**DESIGN ANALYSIS REPORT
FOR THE
STA-1E CELLS 1-2 PSTA/SAV
FIELD-SCALE DEMONSTRATION PROJECT**

Response to Comments Submitted by STADG on the June 2005 Draft Design Analysis Report for Cell 2

Response to Comments Submitted by STADG on the April 2005 First Draft Design Analysis Report for Cell 2

Response to Comments Submitted by STADG on the April 2004 Draft Design Analysis Report for Cell 4S

Figure 3. Flow Diagram for the C-51/STA-1E PSTA/SAV Field Demonstration Project (Cells 1 and 2). Not to Scale.

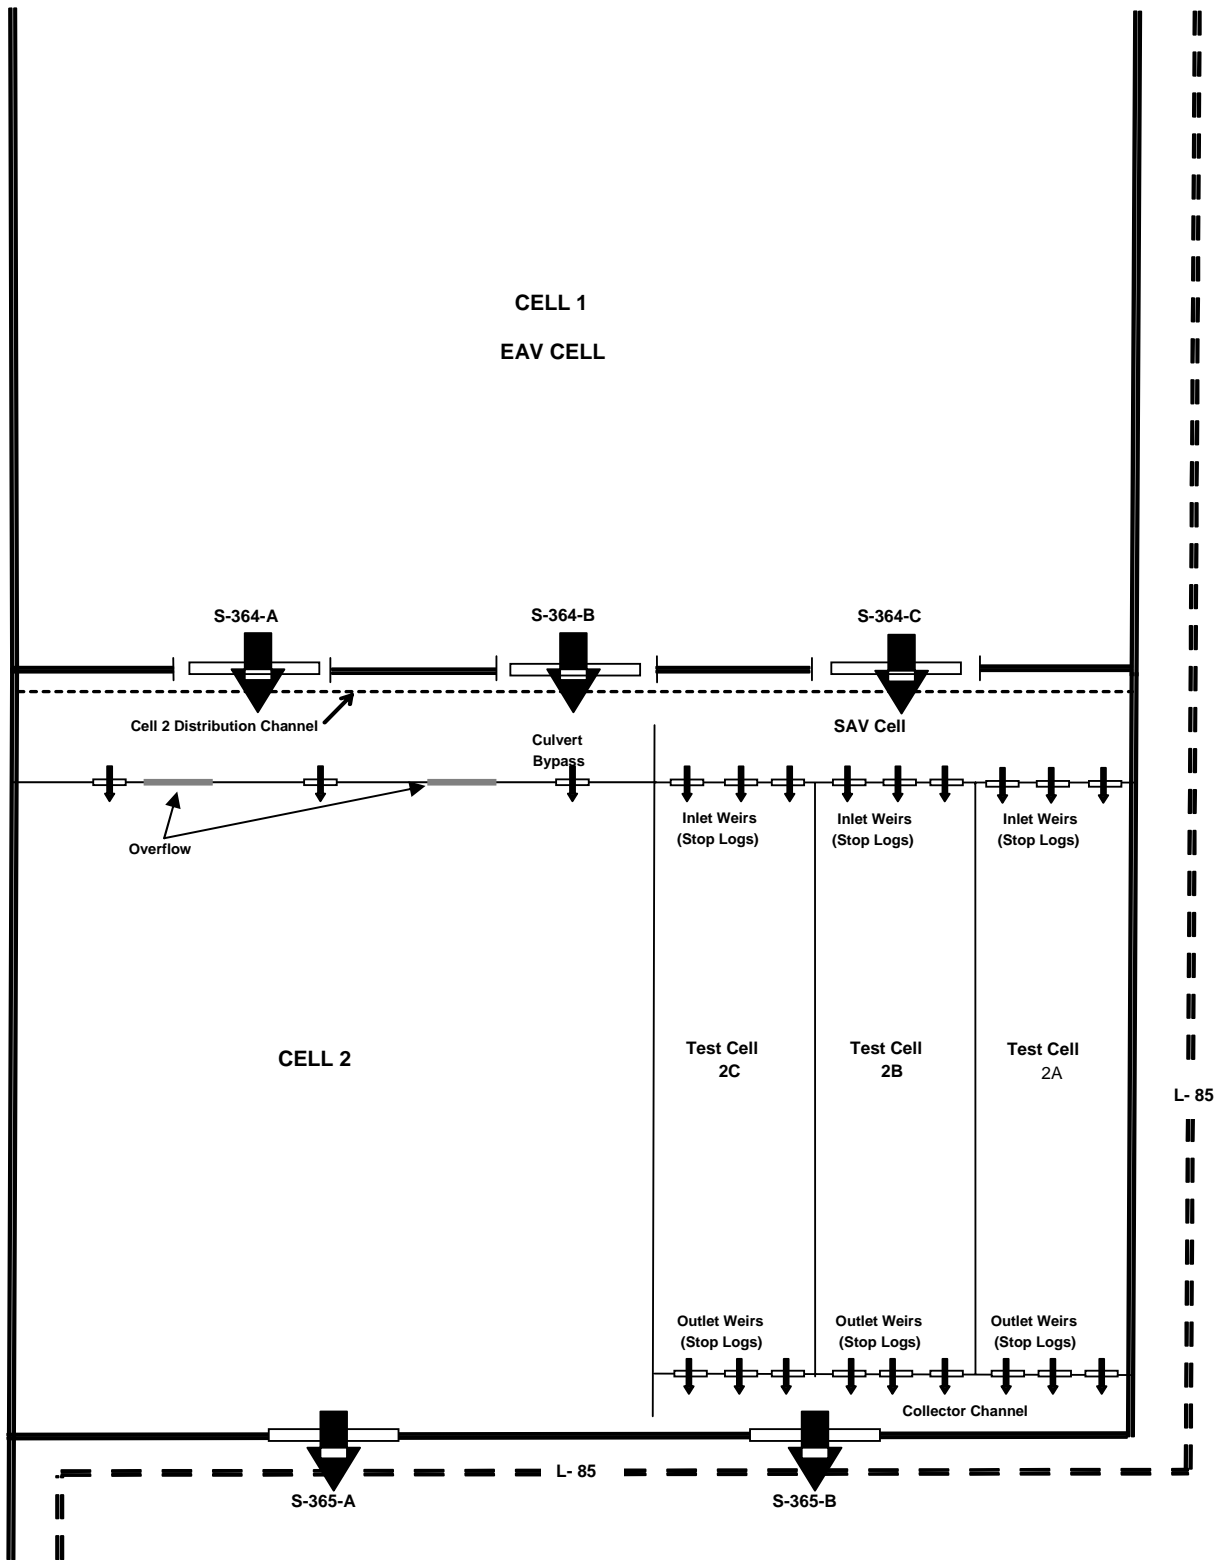
6	Page 4 (Figure 3). Eighteen stop logs structures are proposed (six per test cell). Why do you need so many structures? If required, would this mean 48 structures would be needed if project later expanded to all of cell 2? SFWMD would need the control structures to be automated/telemetry for us to operate	<p>Three stop-log structures are proposed at each inlet or outlet to allow flexibility and sensitivity in controlling flow, smaller log sizes for easier maintenance, and redundancy. The use of stop-log structures is only for the purpose of the test demonstration project; stop-log structures are not proposed for permanent operations in STA-1E and would not be expanded to other cells.</p> <p>Operations, monitoring, and maintenance of the PSTA Demonstration Facility will be the responsibility of the USACE and its contractors.</p>
7	Page 5 (Table 1). Section 2 of Table 1 states "For the draft DAR obtain currently available STA-1E monitoring data to indicate treatment to at least 50 ppb. If verified, use this number as the PSTA cell input concentration." Was this done?	Available data was obtained; however, it was insufficient to determine PSTA cell input concentrations, due to both very few data points and STA operations at the time of data collection.

PLATE NO.
W 202

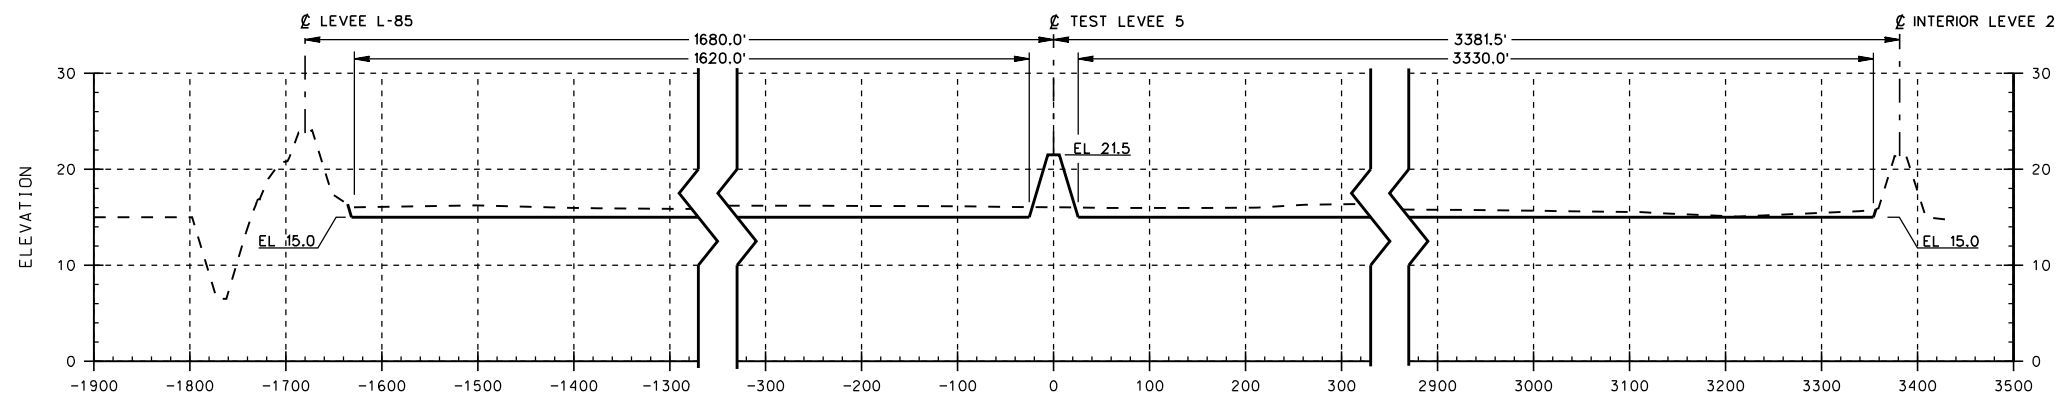
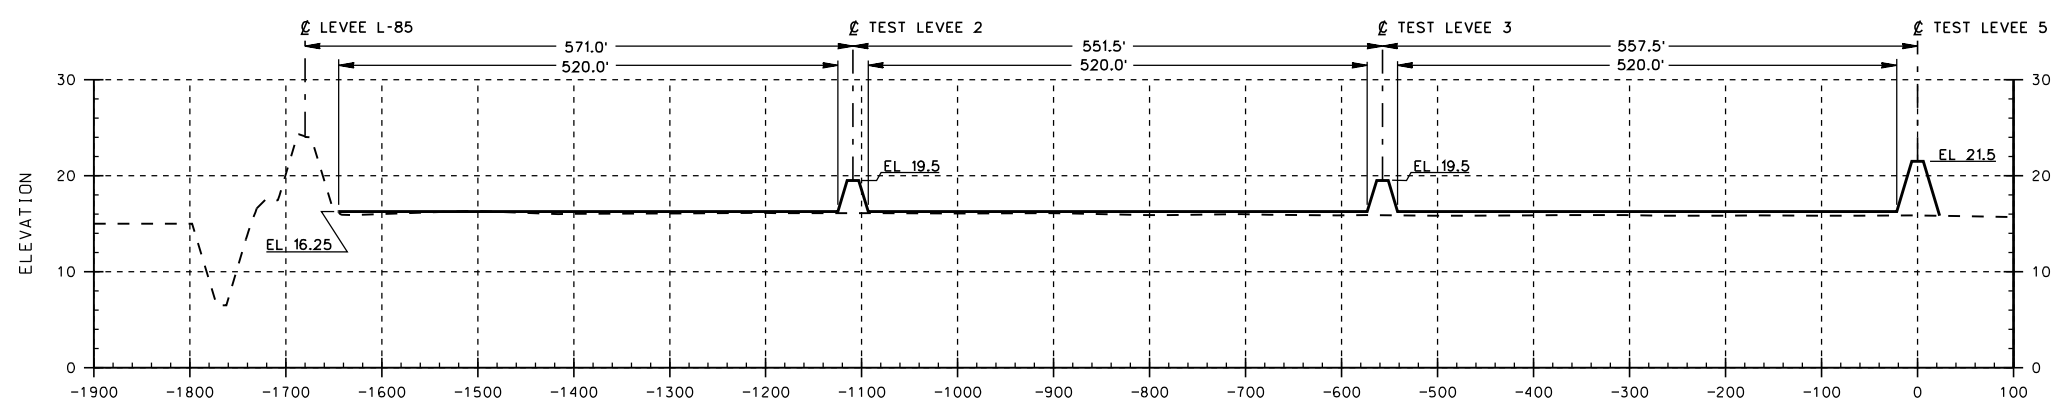
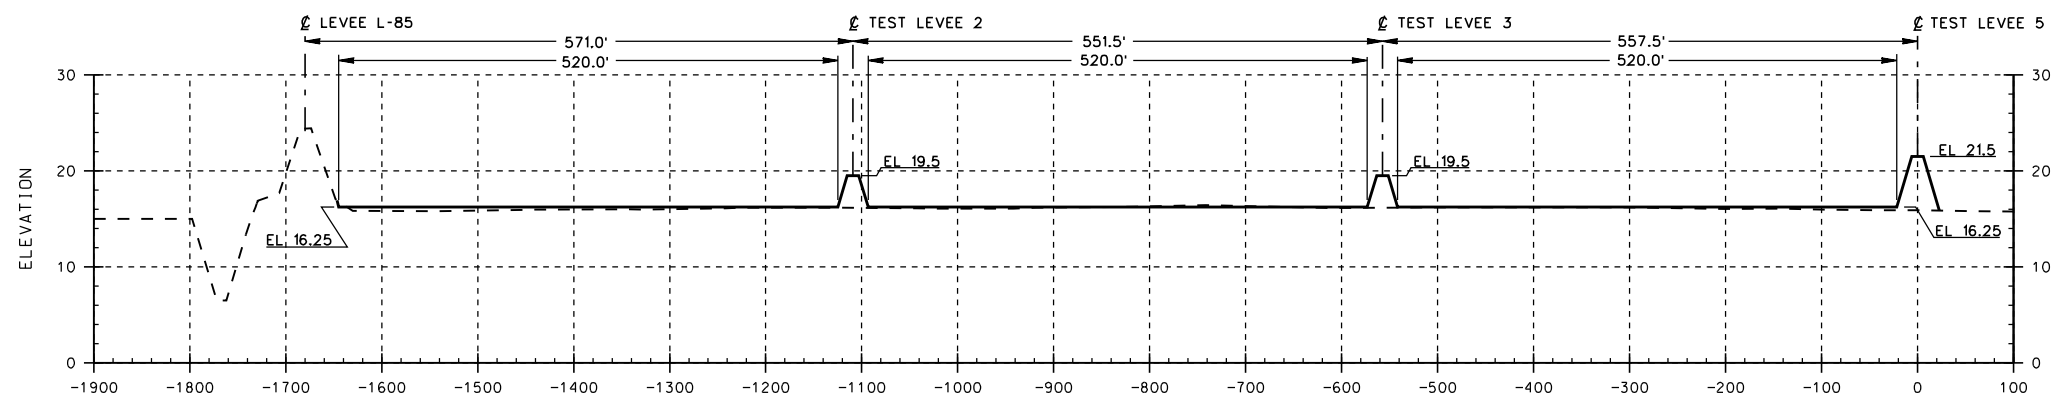
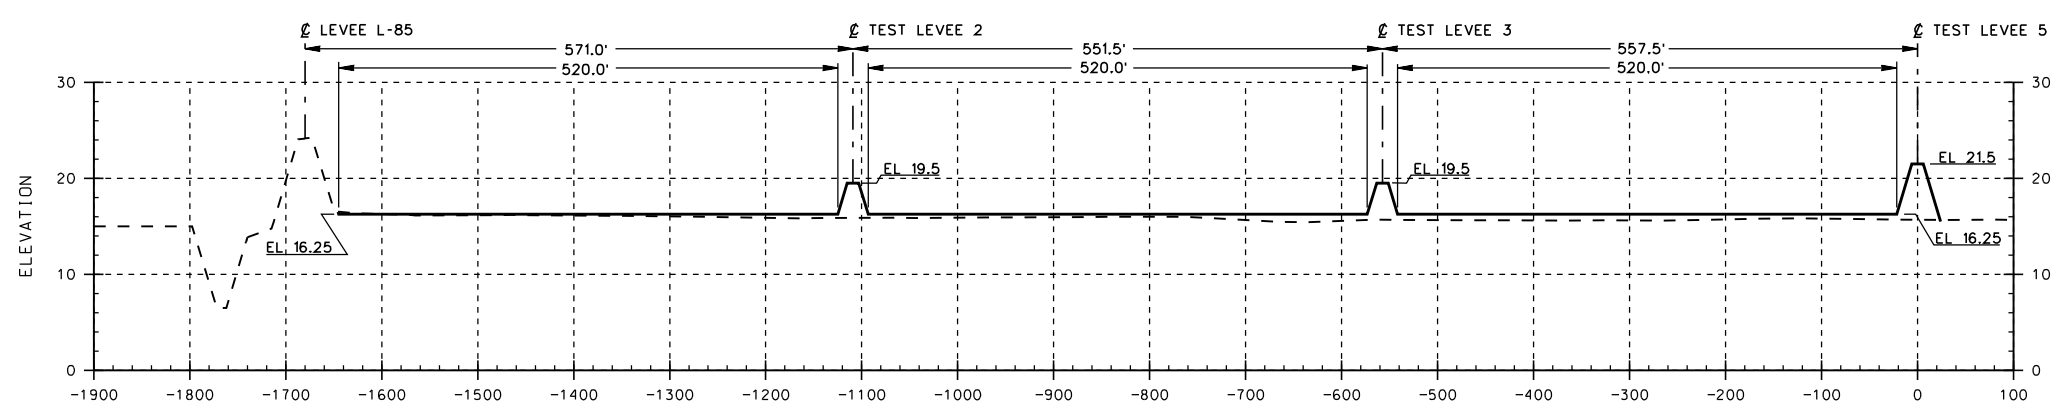
5	<p>page 6 –</p> <p>i. The tolerance noted in the text (“+/- 0.25 ft”) is inconsistent with the tolerance noted on Plate No. W 203 (“+/- 1.5 inch”). Which is correct?</p> <p>ii. Is the proposed +/- 1.5-inch tolerance (shown on Plate No. W 203) for ground elevation anticipated to be carried forth into the full-scale design?</p>	<p>The typographical error in Table 1 and Section 2.1 will be revised to state a tolerance of +/- 0.125 ft; namely, a 3-inch total variation is tolerable.</p> <p>Grading tolerances will be evaluated at the time of full-scale design.</p>
6	<p>page 7 –</p> <p>i. What tolerance will be provided in the substrate material thicknesses? How will the contractors achieve a depth of 2 inches for the Fort Thompson Formation limestone and 1 inch for the lime sludge?</p> <p>ii. The unexcavated on-site limestone and the stockpiled on-site limestone have lower TP and CaCO₃ characteristics than the other two substrates, so why are the other two substrates (Fort Thompson Formation limestone and lime sludge) being used?</p>	<p>i. Construction specifications will stipulate “minimum” thickness of substrate, not a +/- tolerance. Thickness will be measured by pre- and post-surveys during material placement. Grading to tight tolerances can be achieved using laser grading equipment, such as used in road construction. Contractors using conventional construction equipment (graders, dozers) are capable of placing 2 inches of limestone. The construction contractor will demonstrate the feasibility and practicability of installing a 1-inch layer of lime sludge using agricultural lime spreaders or similar equipment.</p> <p>ii. Fort Thompson Formation limestone is being used as a baseline substrate that has successfully sustained calcareous periphyton utilizing C-51 canal source water. Lime sludge is a low-cost alternative that has been successfully demonstrated utilizing C-51 canal source water.</p>

STADG Comments on April 2005 Draft DAR		Response
12	<p>Appendix A.3</p> <ul style="list-style-type: none"> i. The footnote identified a critical concern regarding the proposed configuration of the inlet/outlet pipes shown in Plate No. W 203: the risers are located approximately 30 feet inside the pipes, which will make it hard (impossible?) to inspect and maintain the culvert and risers. Suggest the risers be placed on the end of the pipes and a boardwalk constructed to manipulate the flashboards. ii. Is the weir equation appropriate for the proposed pipe/riser configuration? Does the 3-ft diameter pipe flow control or does the 4-ft weir control the flow? iii. Placing the pipes on the bottom of the collection canal will likely lead to flow obstruction due to sedimentation over time. Not sure the invert of the outlet 3-ft diameter pipe needs to be at 12.0 ft NGVD since the test cell ground elevation is 16.25 ft. 	<ul style="list-style-type: none"> i. Noted. The current configuration is preferred. Vegetative growth and debris are expected to be minor and could be removed from the stop-log riser structure. Access to the culvert inlets remains the same. ii. The weir equation controls flow for the proposed pipe/riser system using the stated assumption that the weir will have free discharge with no submergence due to tailwater effects. If the system has to be run under a submerged condition, flow meters will need to be used to set the outflow from the barrels when adjusting the boards. For the flow levels required, if control switches to outlet control, the system will still be able to pass the required volumes. iii. The suggestion to raise the inverts a few inches off the bottom of the distribution channels will be considered.
